Access Compliance Report

Public Rights-of-Way

Intersection ID: 30168	Main Street: JUNE BERRY CT	Cross Street: SLATER RIDGE DR	Location: SW
ADA ID: EA8C79476192	Ramp Type: BlendTrans1	Initial Pass/Fail: Pass	Overall Compliance: No
		Severity Score: 5

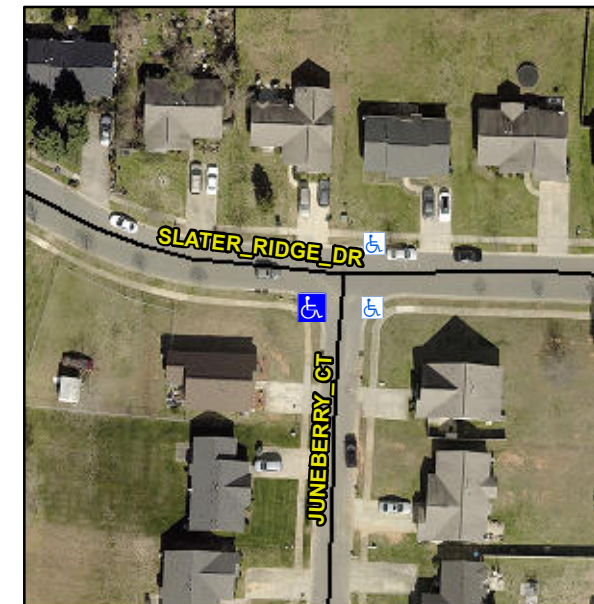
Not Found, R304.2.1, R305.2, R304.5.4

N/A	Ramp inside XWalk1?	N/A	N/A	Ramp inside XWalk2?	N/A
	Road Slope (%)	1.7		Clear Space?	Yes
	Road X Slope (%)	2.1	N/A	Clear Space to XWalk (in)	N/A
Yes	Any Obstructions?	No	Yes	Storm Grate/Utility Hazard?	No
	Obstruction Type			Storm Grate/Utility Type	
		N/A			N/A
			Yes	Surface Condition? (G/P)	Good
			No	Curb Slope (%)	5.7

Remove & Replace Curb Ramp With Two New Directional Ramps or Equivalent. Remove & Replace Gutter.
